Final Environmental Impact Report

Meridian D-1 Gateway Aviation Center Project

SCH NO. 20210400012

DECEMBER 2025

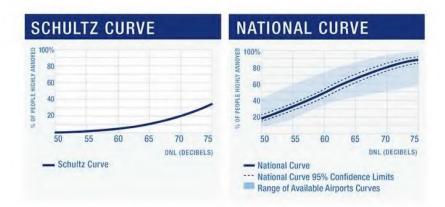
3) I also question the accuracy of the measurements shown in Tables 3.11-33 and 3.11-34 for the Reference Ambient Noise Levels and the Combined Project and Ambient noise levels, all but one of which are *identical* numbers to a 10th of a dB (there are no units in the table; I assume these are dBA measurements). Federal noise measurement policy generally dictates

rounding up; accuracy to tenths of a dB is highly unlikely (e.g., FTA manual). In addition, it is impossible that there is no additional noise if there are cargo flight operations during the daytime and nighttime, especially if the majority of the operations are during the day (average of 34 additional cargo flights). This claim greatly reduces the credibility of the data analyses.

EAST ELEVATION

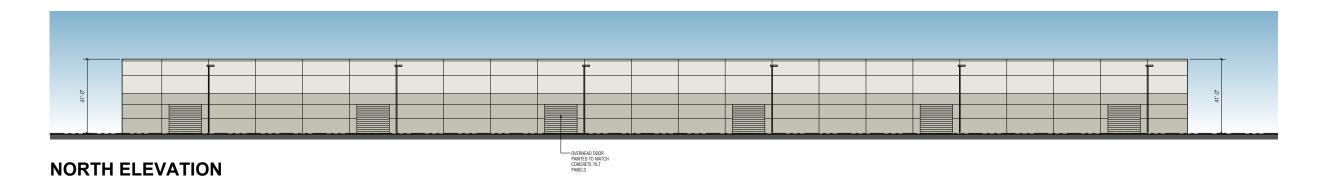
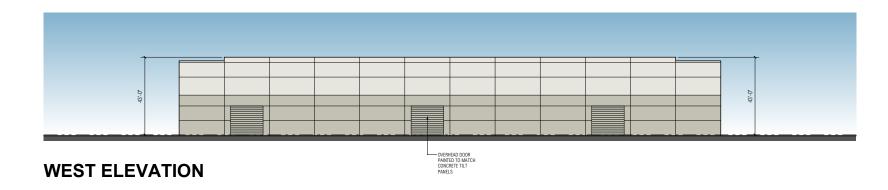
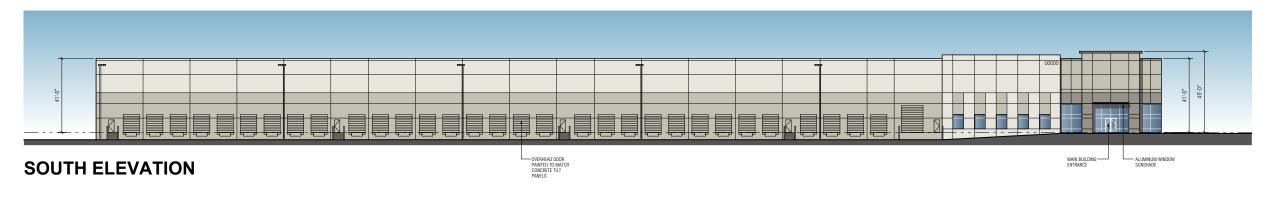
- o Figure 2-6 Cargo Building Elevations
 - This elevation does not match the site plan. This elevation shows +/-42 dock doors, project description and site plans reflect 31.
